PG&E Letter DCL-15-095

Diablo Canyon Units 1 and 2

Response to NRC Request for Additional Information Regarding Recommendation 2.1
of the Near-Term Task Force Seismic Hazard and Screening Report

Response to NRC Request for Additional Information Regarding Seismic Hazard and Screening Report

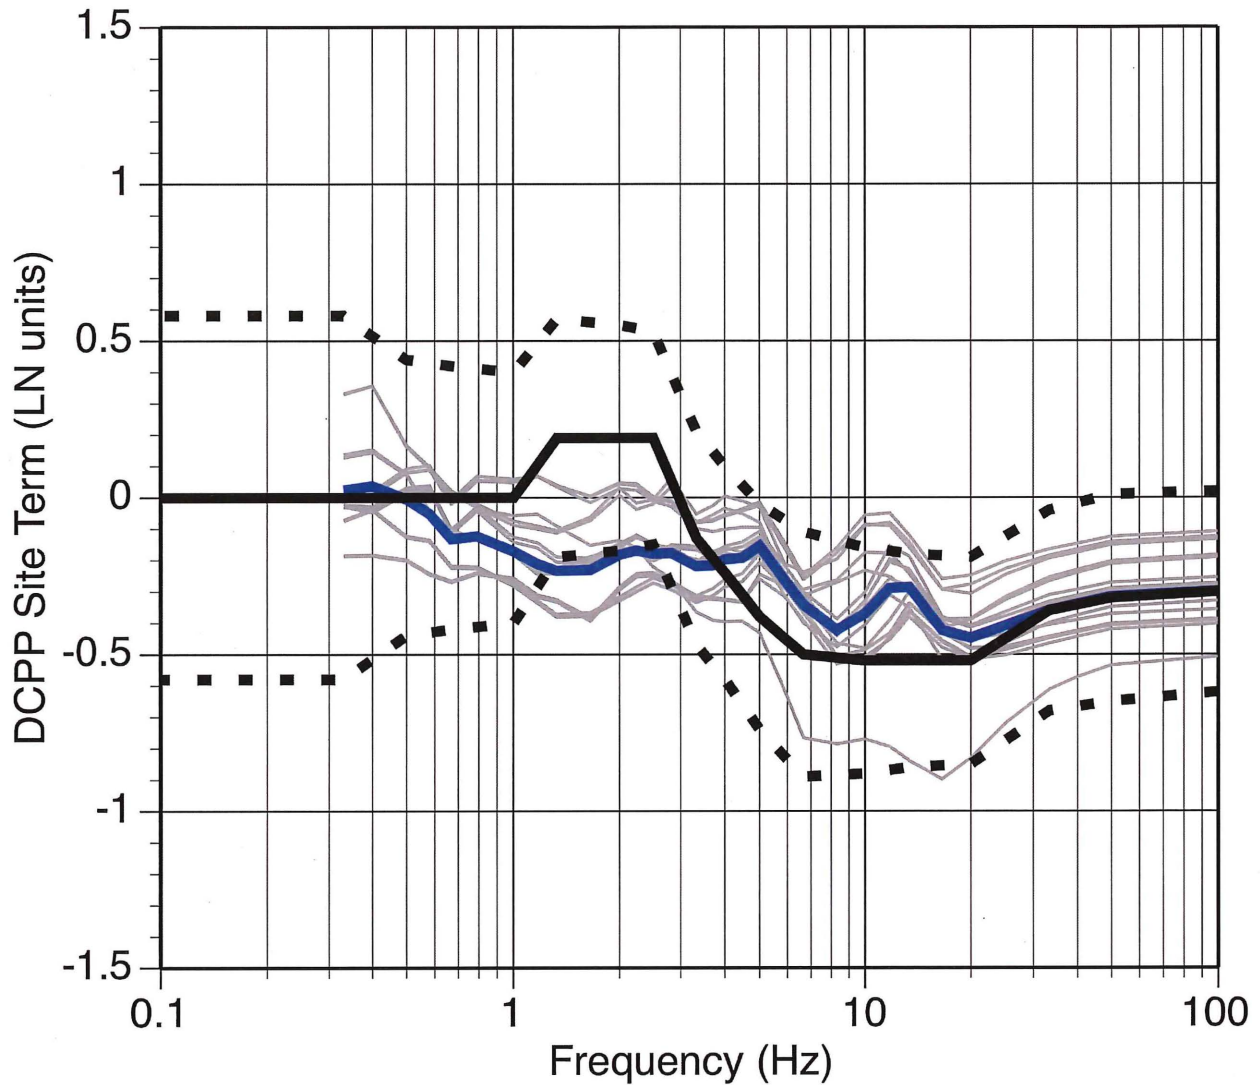
Consistent with the request for information issued pursuant to Title 10 of the Code of Federal Regulations, Part 50, Section 50.54(f) and the Screening Prioritization and Implementation Details (SPID) guidance, a supplemental response to the March 2015 seismic hazard reevaluation that develops site amplification factors as recommended in Section 2.4 and Appendix B of the SPID is requested. Please provide (1) a detailed description of the subsurface profile properties including uncertainties, (2) the potential for nonlinear behavior at the strain levels produced by the scenario earthquakes of interest, and (3) the control point elevation. In addition, provide the adjustment factors (VS-kappa corrections) needed to modify the median ground motion models for the selected reference or baserock elevation and velocity. Also include in the response, as a figure and a table, control point seismic hazard curves developed using the site amplification factors and their uncertainties through the hazard integral as recommended in Appendix B of the SPID.

A comparison of the resulting site amplifications from the analytical modeling approach and the empirical data approach is shown in Figure 1. The black curves show the mean and range of the empirical site terms used in the March 2015 submittal. The blue curve shows the mean amplification from the analytical modeling for a kappa of 0.040 seconds (sec) for a reference rock peak acceleration of 0.1g that is representative of the linear response range which is consistent with the level of shaking from the empirical data used to compute the empirical site terms. The gray curves show range of the amplification for different assumptions of the velocity profile and the nonlinear site parameters for a kappa of 0.040 sec. These alternative cases are described in detail in the response to the questions.

Figure 1 shows that the site terms from empirical model are generally consistent with the site terms from the analytical modeling for the high frequencies. Stronger resonances are seen in the analytical model results (e.g., 12 hertz (Hz)) which is a

common feature of site response based on 1-D velocity models. At the 1-3 Hz range, the analytical modeling leads to lower amplification than the empirical model because the shallow velocity model used in the analytical modeling does not capture the effects of the site-specific deep velocity profile, whereas, the empirical model captures the effects of the full velocity profile.

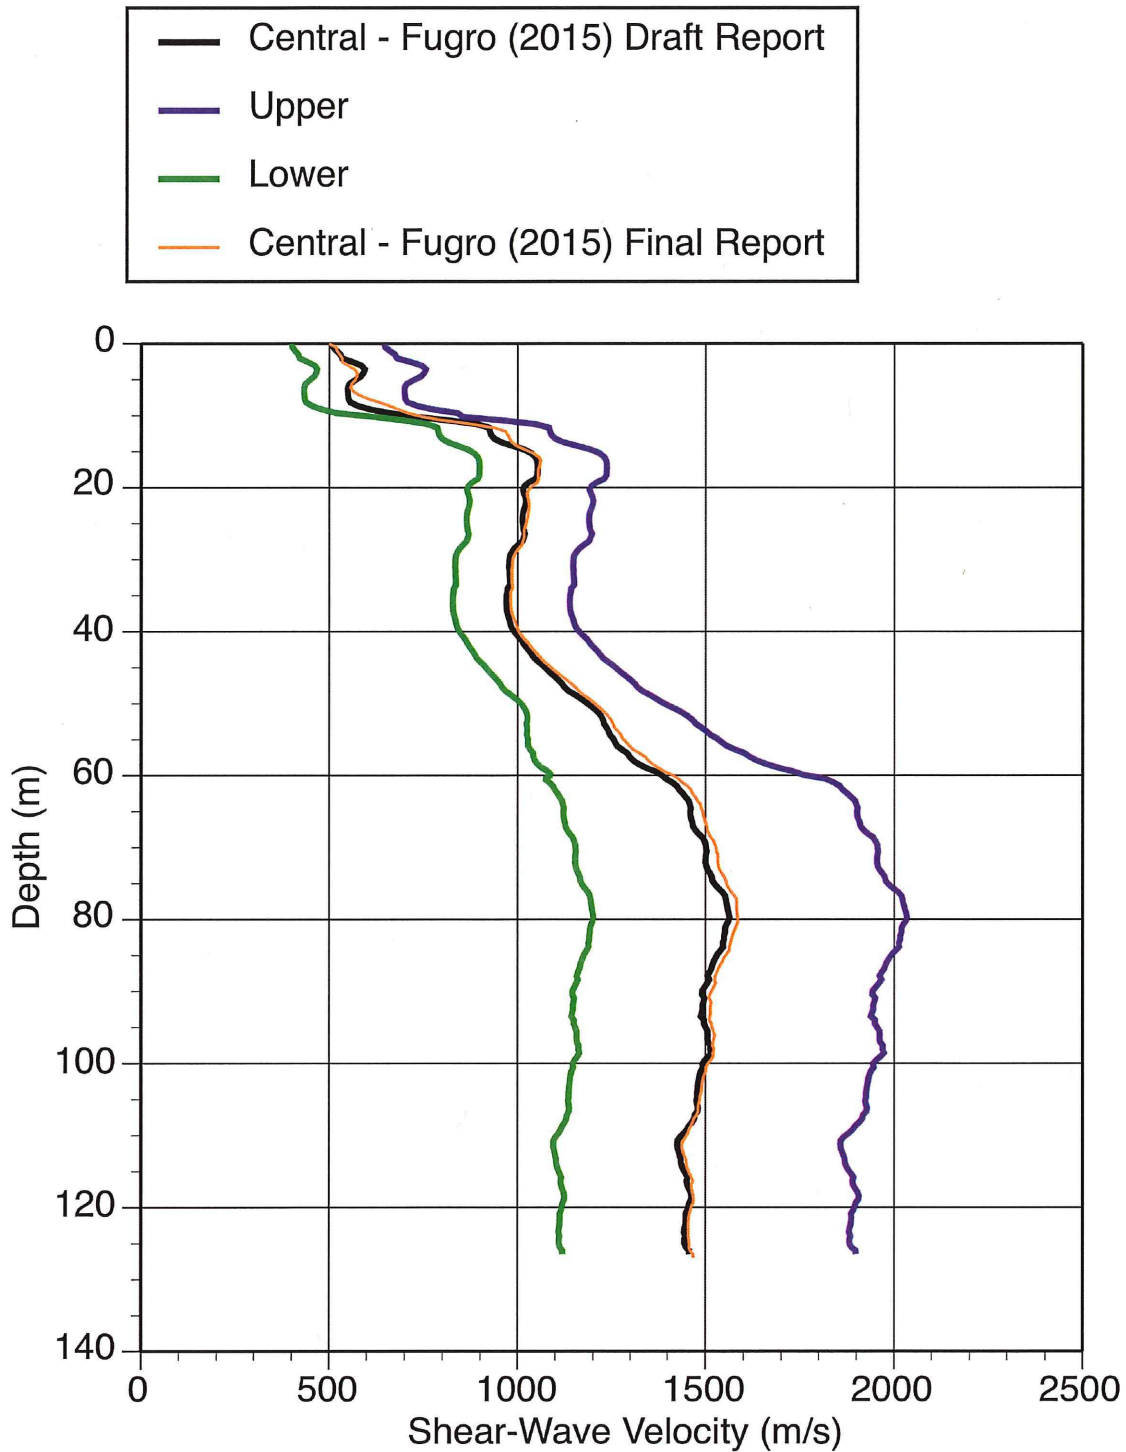
Please provide a detailed description of the subsurface profile properties including uncertainties.

For the Free-Field Seismic Instrument Control Point (ESTA28, Elevation 85 ft), the VS profile was developed using a representative 1-D profile from the 3-D model (given in Appendix H of Reference 3). The uncertainty in the 3-D velocity model was also addressed in Reference 3 (Section 3) and the recommended uncertainty range is listed in Table 1-1 below. Using this uncertainty estimate, the epistemic uncertainty in the VS profile at ESTA28 was developed using plus or minus 1.6 times the standard deviation (approximates the 5th to 95th fractile for the uncertainty) at all depths. The three alternative base velocity profiles for the shallow part of the profile (to a depth of 126 meters (m)) are plotted in Figure 1-1 below. Because these profiles represent the 5 to 95 percent range, the logic tree weights are 0.6 for the central model and 0.2 each for the upper and lower models.
